## Product Change Notification

LDTC2/2E &amp; LDTC2/2O → Revision C

**Subject: Part Change**

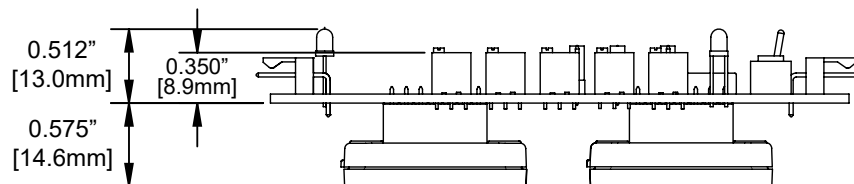
The LDTC2/2 Product Series have been revised to include a new and robust set of pins for the WLD and WTC units on-board to enhanced functionality and productivity. The LDTC2/2 products will have new sets of pin sockets. This increases the overall height of both the LDTC2/2E and LDTC2/2O.

- New pin sockets for simplified module replacement
- The overall heights of the LDTC2/2E and LDTC2/2O have increased

**NEW HEIGHT  
LDTC2/2E**

**OLD HEIGHT  
1.14" [29.0mm]**
**NEW HEIGHT  
LDTC2/2O**

**OLD HEIGHT  
LDTC2/2O**

**Action Required: Evaluate Effect of LDTC2/2E & LDTC2/2O Height Change**
